REQUEST FOR INFORMATION

Hope Bay Mining Project

Subject:	North Dam – Frozen Core Construction	Project Zone/Area:	Doris North Project
Company:	SRK Consulting (Canada) Inc.	Station/Location:	North Dam Sta. 0+70 to Sta. 1+20
Attention:	Lowell Wade	Discipline:	Civil

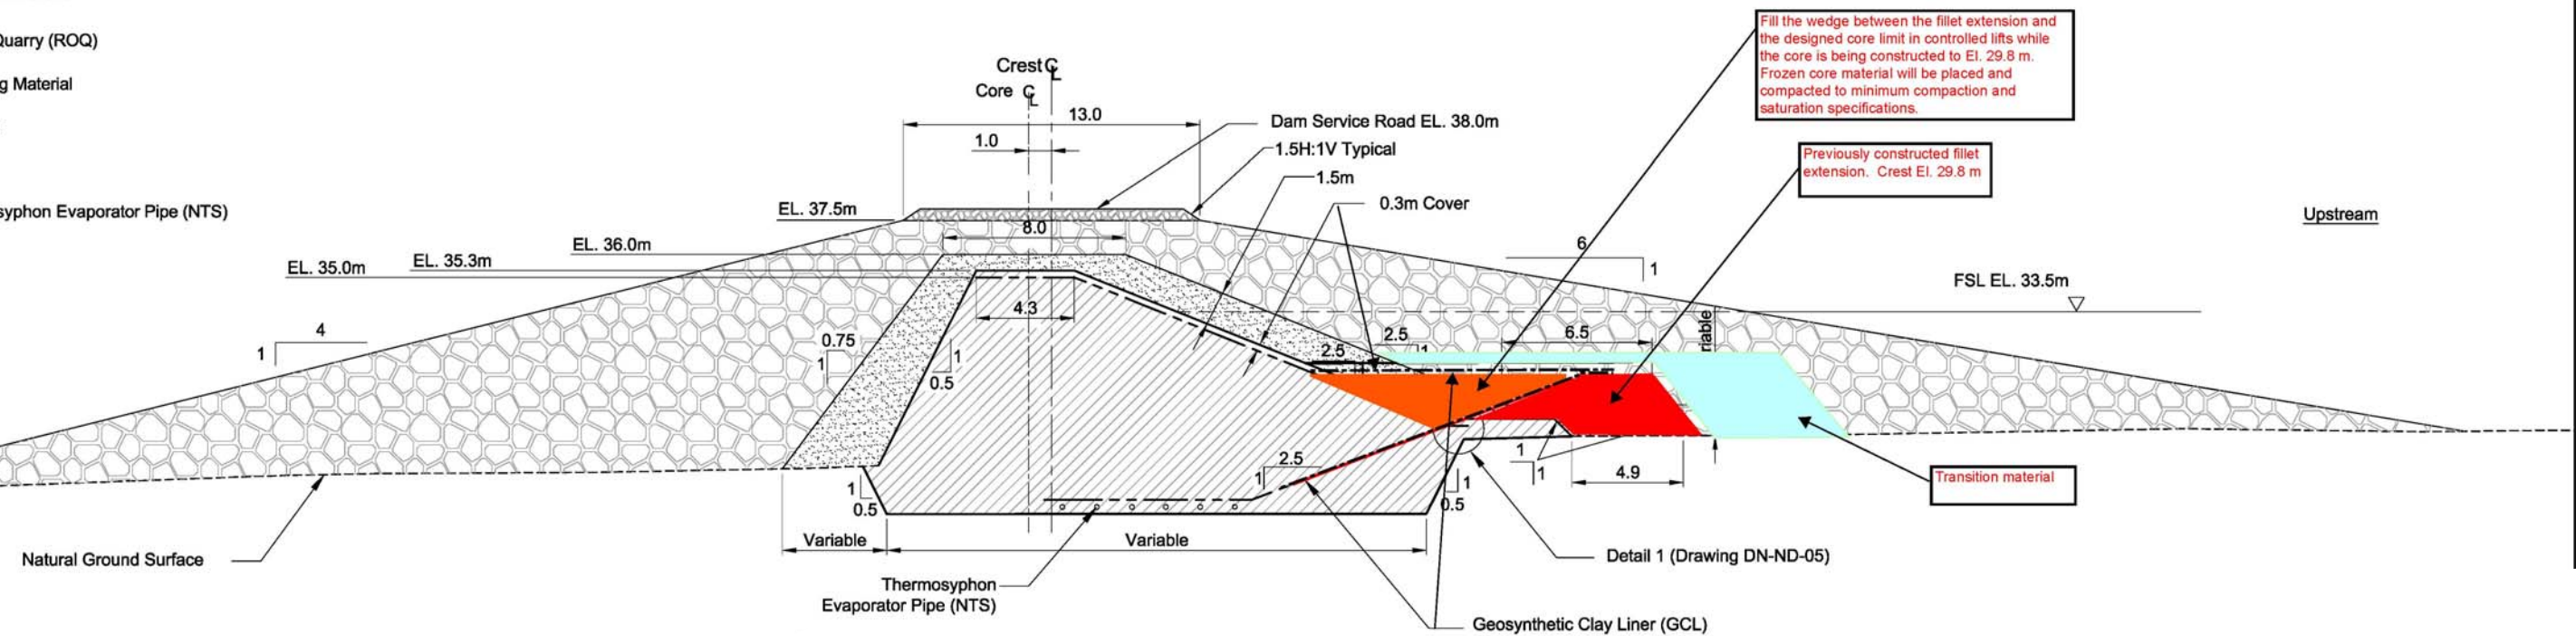
Information Request/Description of Issue/Approval Required:
Proposed Corrective Action:
It is our intent to construct the frozen core to El. 29.8 m in controlled lifts that meets the compaction and saturation criteria. This construction methodology will fill the wedge between the design core lines along the upstream side of the core superstructure and the previously constructed fillet extension between Sta. 0+70 and Sta. 1+20. The upper GCL panels will overlap the lower GCL panels by the required 1.0 m on the horizontal plane of the fillet extension at El. 29.8 m. The upper GCL panels will extend on the horizontal plane at El. 29.8 m to the point where they meet the 2.5H:1V upstream slope of the frozen core where they will then continue as per the IFC drawings. The minimum GCL cover (0.3 m) dimension and subsequent minimum cover of transition material will be maintained.
Originator: Mark Valeriote

<input type="checkbox"/> Corrective Action Approved	<input type="checkbox"/> Correct as Follows:
Response:	
Responsible Newmont Representative:	
Print:	Sign: Date:

NL-RFI-78

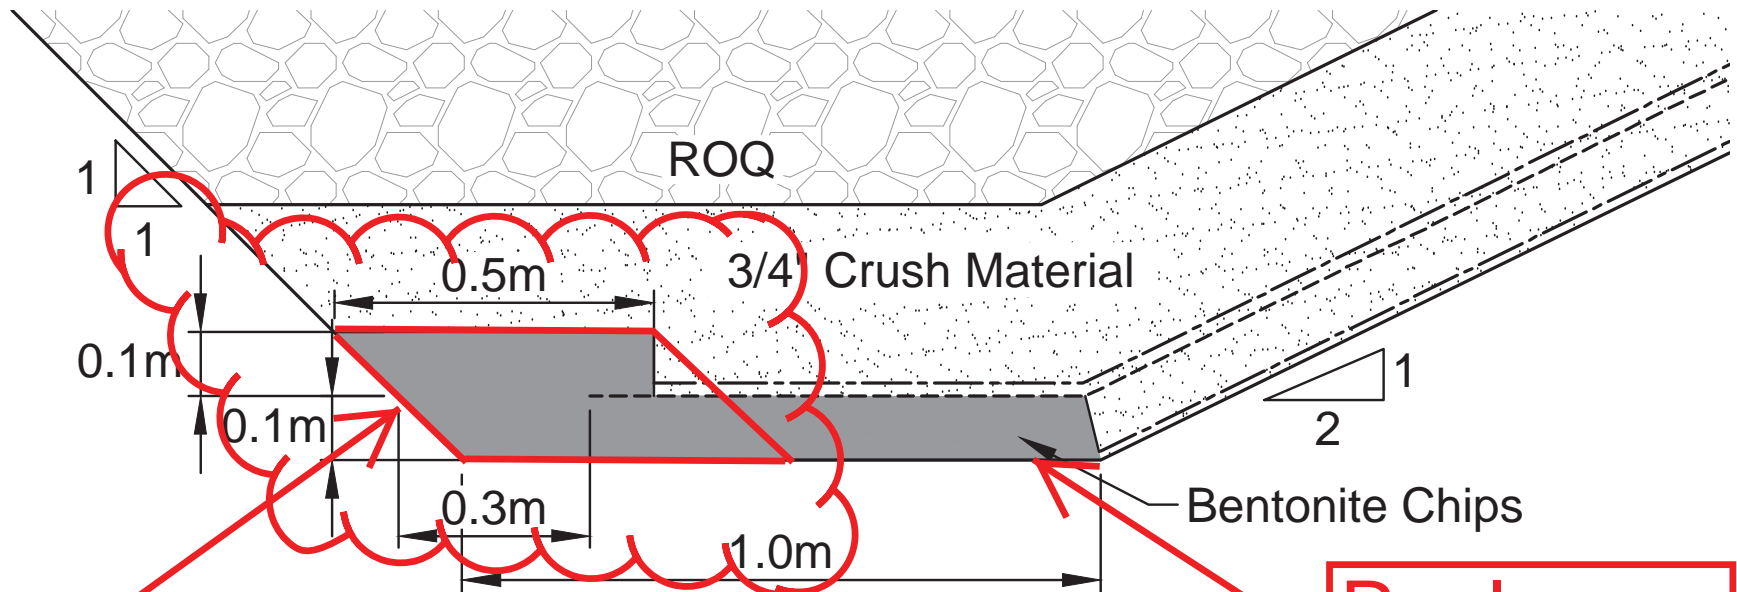
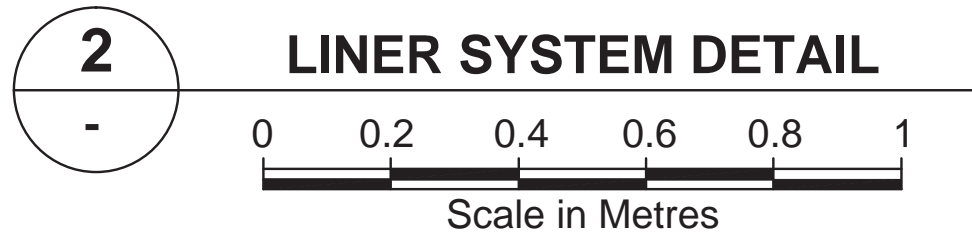
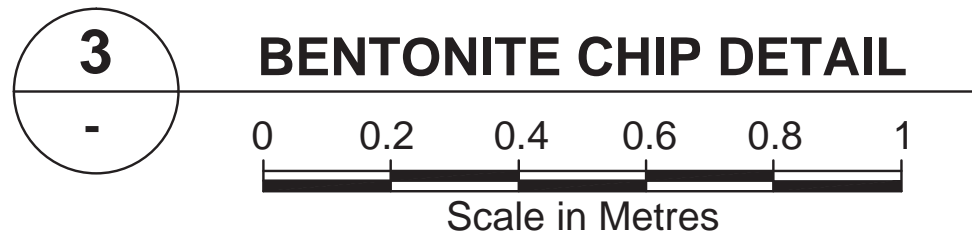
Information Request/Description of Issue/Approval Required:	
To reduce the quantity of Bentonite required in the bottom of the keytrench to seal the HDPE liner interface.	
Proposed Corrective Action:	
<ul style="list-style-type: none"> Instead of placing the bentonite the full width of the keytrench in a 0.1 meter lift, EPCM proposes to place a bentonite plug at the liner to crush interface. The underliner bentonite layer downstream of the bentonite plug would be replaced by crush. 	
See attached drawing.	
Originator:	Ishan Fechter
Print:	Sign: 
	Jan. 21, 2012
	Date:

Bentonite Plug

Replace with Crush

Response:
<p>SRK does not agree with the proposed modification and recommends the IFC design, as provided, be followed. The longer zone of bentonite chips under the liner has been designed to reduce the potential hydraulic gradient due to the longer seepage path which will reduce the risk of seepage under the liner. The proposed Bentonite Plug does not address the potential hydraulic gradient issue.</p>
Responsible Newmont Representative:
Lowell Wade
January 23, 2012
Print: Sign: Date:

Doris Camp Sump Section and Details

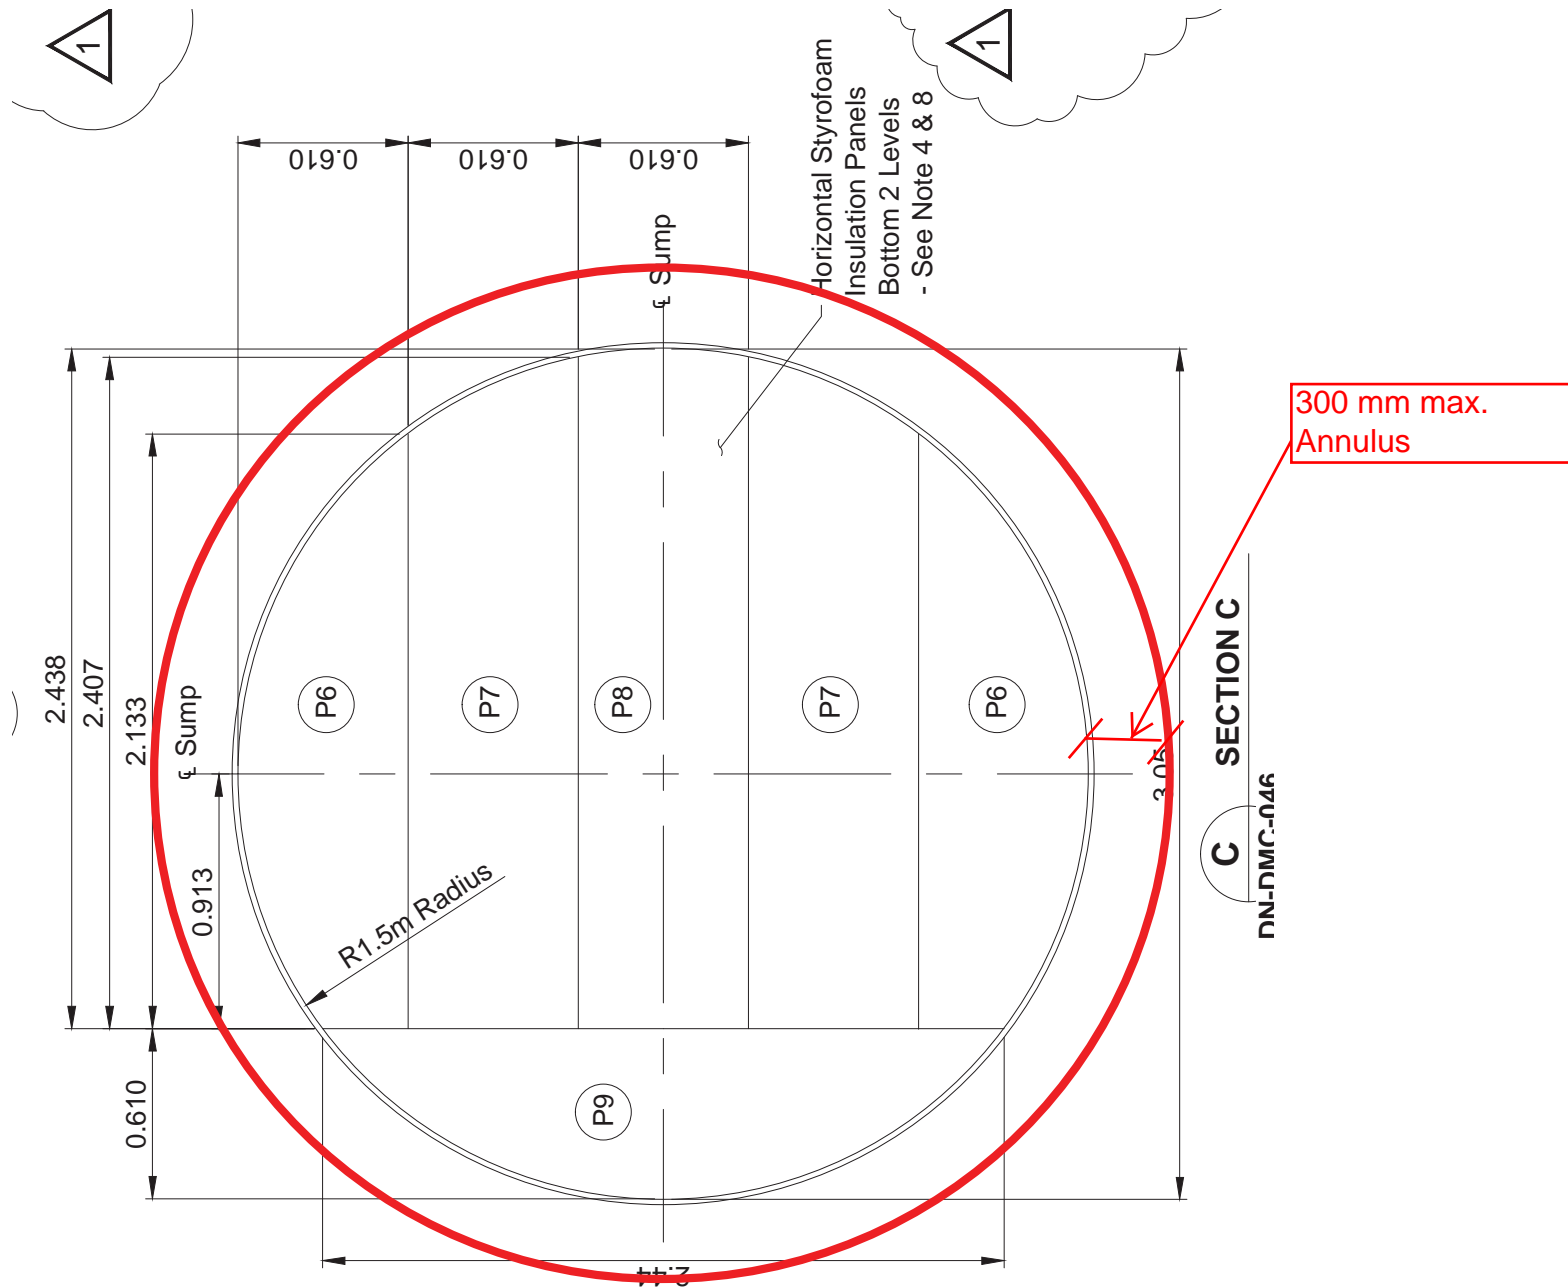
To confirm the maximum annulus acceptable for the sump excavation, as discussed by conference call with Maritz Rykaart SRK on Jan. 11. During that conference call the annulus of 300 mm was approved by Maritz Rykaart..

Please officially confirm that the 300 mm annulus is approved.

A conference call on January 11, 2012 was held to discuss the sump installation. Those in attendance were: JDS [Jerry Graham, Kevin Whieldon], Nuna [Mike Price, Simon Chipper, Nick Stoneberger, Kevin Oakes], SRK [Lowell Wade, Maritz Rykaart], Newmont ESR [Katsky Venter, Angela Holzapfel]. It was agreed the maximum annulus for the sump excavation is 0.3 m. A leveling course of 5/8" material will be place in the base of the excavation to level the sump and the annulus will be backfilled with 5/8" clear material up to 1 m below grade. The upper 1 m of the annulus will be backfilled with the excavated original ground and covered with coconut matting. The lid of the sump will be increased in diameter to ensure the area of disturbance, caused by the excavation, will be protected from direct exposure to the sun.

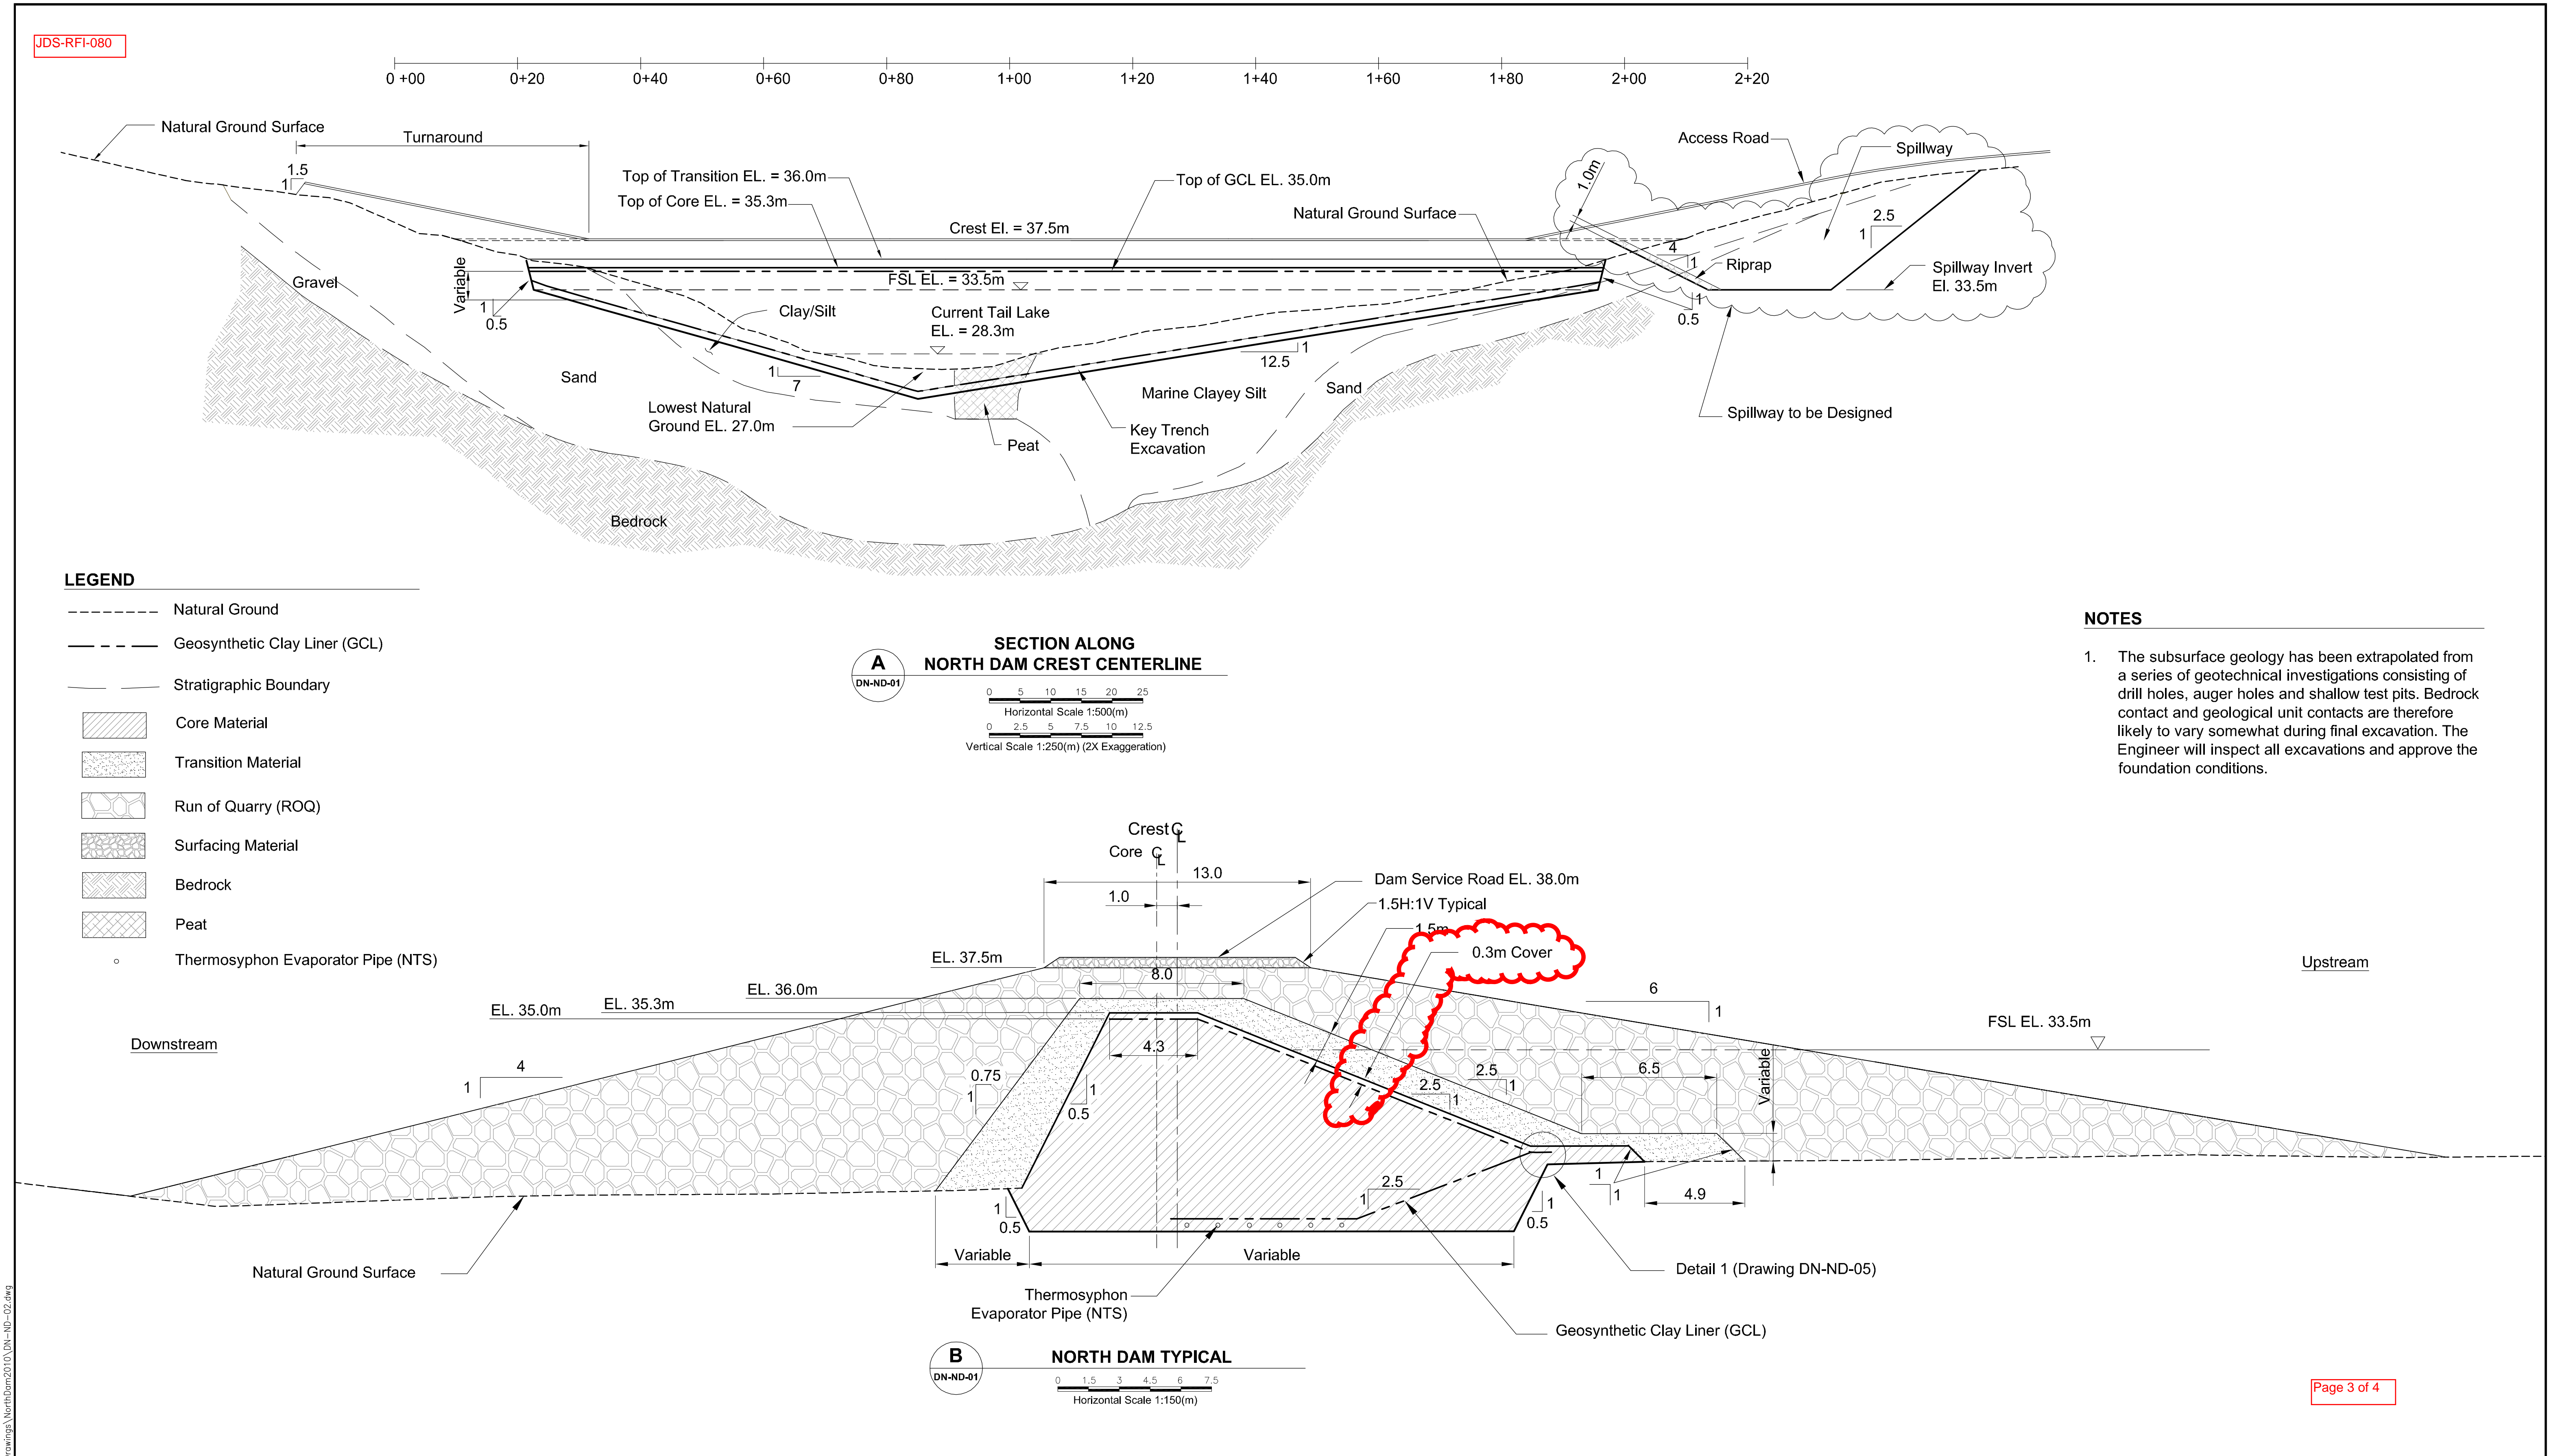
SRK Drawing No: DN-ND-02 (refer to attachment) shows 0.3 m of cover material placed above the upper panel of GCL. The cover material is illustrated as being "core material". The cover material refers to the material upstream and on top of the upper GCL placed on the upstream slope and over the crest of the frozen core material. Technical Specifications Revision "G" Section 5.2.7 Core Material, Table 5.4 (refer to attachment) provides the particle size distribution limits. Technical Specifications Revision "G" Section 6.4.3 GCL Cover (refer to attachment) outlines the parameters with placing cover material. Technical Specifications Revision "G" Section 6.4.3 GCL Cover specifies the material must be compacted to a maximum of 90% of the maximum dry density (ASTM D698) to prevent damage to the GCL.

It is our intent to use granular material that was processed between mid-January up until the beginning of March 2011. This material meets the particle size distribution limits noted above.

It is our intent to use granular material that was processed as frozen core material prior to March 2011. This material meets the particle size distribution limits outlined in Technical Specifications Revision "G" Section 5.2.7 Core Material, Table 5.4.

The proposal of placing granular material, processed as frozen core material prior to March 2011, over the GCL is acceptable. As mentioned above all the lines and grades shown on the IFC Drawings and the appropriate sections of Technical Specifications Rev. G are to be maintained.
